HISTORIC PRESERVATION COMMISSION REVIEW

APPLICATION FOR CERTIFICATE OF APPROPRIATENESS

LOCATION OF PROPERTY: 817 Main Street, Greenport, NY 11944

RE: 817 Main Street – Fence Modifications

ENLARGED SITE PLAN

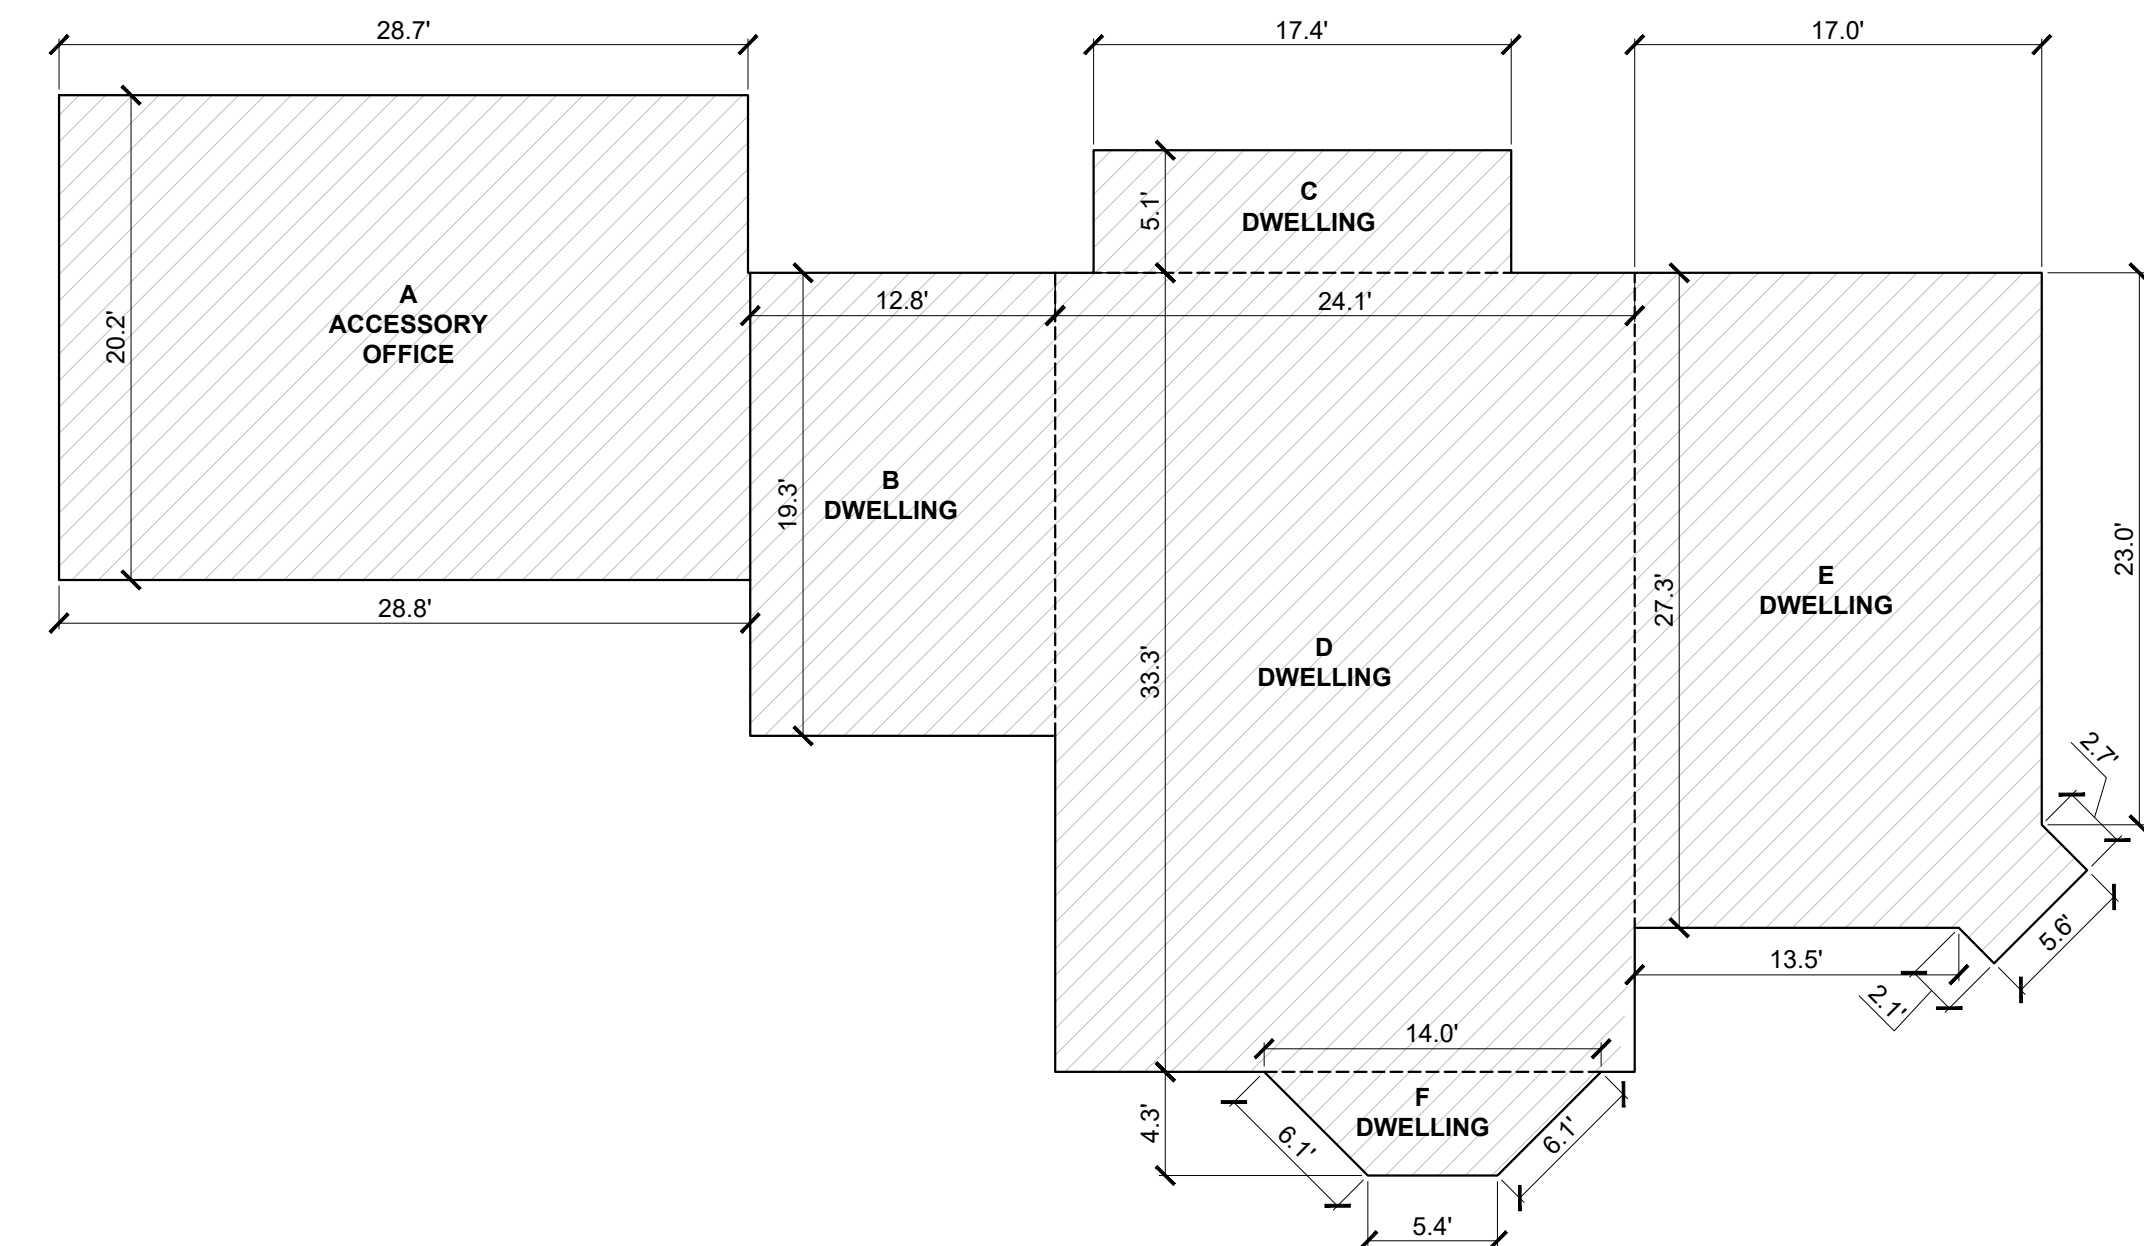
1. **Comment:** Provide an additional privacy fence on the southern property line, between the rear parking area and the adjacent property of 809 Main Street.
 - a. **Response:** We have already received approval from the Historic Preservation Commission for a brick wall at the end of the driveway and an engineered wood slat privacy fence on the north property line. We are proposing either of these material types as the additional privacy fence that was requested. See Keynote 17 on Enlarged Site Plan 1/A.051.

2. **Comment:** The north property line, between the office walkway and the adjacent property of 823 Main Street, has a density of existing evergreen trees and a wire fence already in place.
 - a. **Response:** We have eliminated the engineered wood slat fence that was proposed along the north property line and will keep the existing evergreen trees. See Keynote 9 on Enlarged Site Plan 1/A.051

3. **Comment:** Vehicles exiting the rear parking area cannot make a left turn onto Webb Street, as this is a one-way street.
 - a. **Response:** We will provide a custom sign at the existing driveway gate stating “No Left Turn.” See Keynote 18 on Enlarged Site Plan 1/A.051.

- 8 PROVIDE 4'-0" TALL WOOD COMPOSITE FENCE IN FRONT YARD
- 9 EXISTING ROW OF EVERGREEN TREES TO REMAIN BETWEEN OFFICE WALKWAY AND PROPERTY LINE.
- 10 DUSTLESS ASPHALT SURFACE (ZR 150-16 (A)(5)).

- 17 EXISTING HEDGES TO REMAIN. REPLACE WIRE FENCE WITH 6' TALL WOOD SLAT PRIVACY FENCE OR BRICK WALL.
- 18 PROVIDE CUSTOM SIGN AT EXISTING GATE STATING "NO LEFT TURN".
